RE: N/F (remaining land of) Kingswood Estates, Church Street, Brooklyn

KINGSWOOD ESTATES

EROSION CONTROL PLAN & CONSTRUCTION DETAILS SUBDIVISION OF LAND

I have reviewed the revised plans for the Bell's 3-lot subdivision on Church Street, which were prepared by PC Survey Associates. Here is what I found with respect to my previous comments of July 12, 2020:

SHEETNO: 3 OF 5

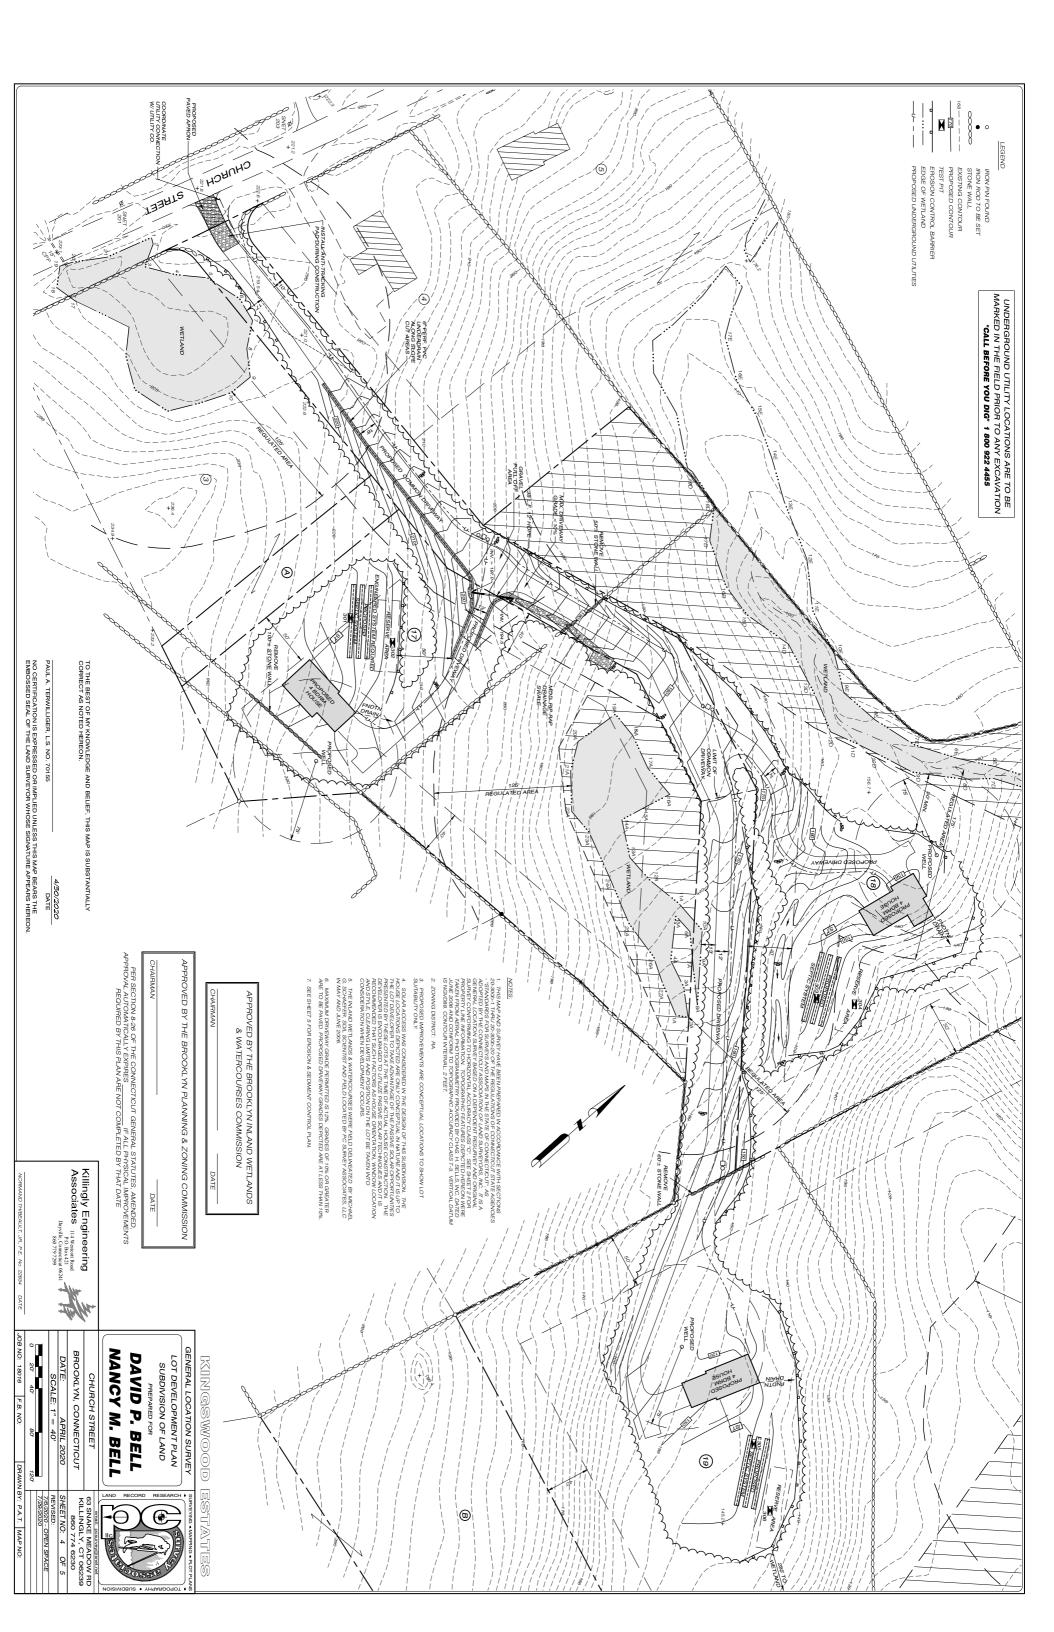
Sheet 3 of 4

Even though a letter from NDDH to the Bells was submitted to you, PC Survey did not provide their explanation as requested. I believe it is important to know why this note was placed on the plan.
